# Access Compliance Report

## Public Rights-of-Way

### (Curb Ramps)

Intersection ID: 10014572	Main Street: SCOTT_CREEK_DR	Cross Street: N/A	Location: SE
ADA ID: 8AB028782074	Ramp Type: Perp	Initial Pass/Fail: Fail	Overall Compliance: No
Codes/Mitigation Info/Possible Solution		Field Measurements/Component Compliance	
Severity Score: 25

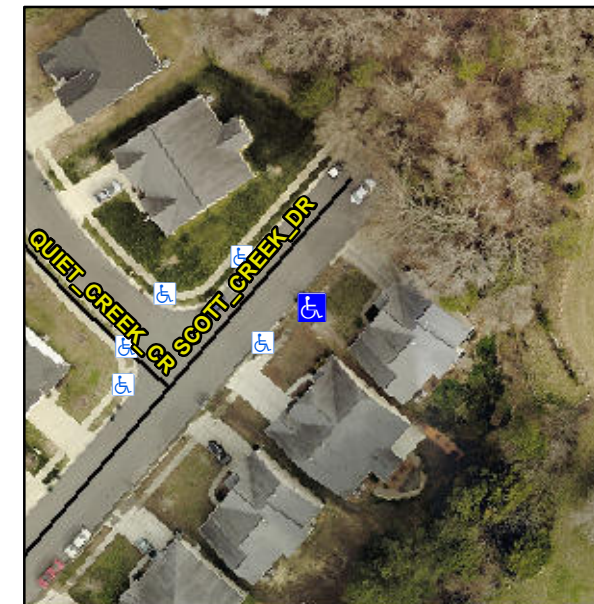
**Not Found, R304.2.2**

Compliance	Description	Data	Compliance	Description	Data
N/A	Ramp Length (in)	44.0	No	Ramp Slope (%)	15.4
Yes	Ramp Width (in)	48.5	Yes	Ramp XSlope (%)	1.9
N/A	Flare Type LT	N/A	N/A	Flare Type RT	N/A
N/A	Flare Slope LT (%)	N/A	N/A	Flare Slope RT (%)	N/A
N/A	Flare Traversable LT?	N/A	N/A	Flare Traversable RT?	N/A
N/A	Landing Length (in)	N/A	N/A	DWS Provided?	N/A
N/A	Landing Width (in)	N/A	N/A	DWS Contrast?	N/A
N/A	Landing Slope (%)	N/A	N/A	DWS Length (in)	N/A
N/A	Landing X Slope (%)	N/A	N/A	DWS Full Width?	N/A
N/A	Landing Curb? (Y/N)	N/A	N/A	DWS Offset (in)	N/A
N/A	Shared Landing?	N/A			
N/A	Gutter Ponding?	N/A	N/A	Gutter Slope (%)	N/A
N/A	Gutter Lip Ht (in)	N/A	N/A	Gutter X Slope (%)	N/A
N/A	Painted X Walk1?	No	N/A	Painted X Walk2?	N/A
	X Walk 1 Direction	To NW		X Walk 2 Direction	N/A
N/A	X Walk 1 Width (in)	N/A	N/A	X Walk 2 Width (in)	N/A
	X Walk 1 Slope (%)	1.5		X Walk 2 Slope (%)	N/A
	X Walk 1 X Slope (%)	0.9		X Walk 2 X Slope (%)	N/A

**Remove & Replace Entire Ramp.**
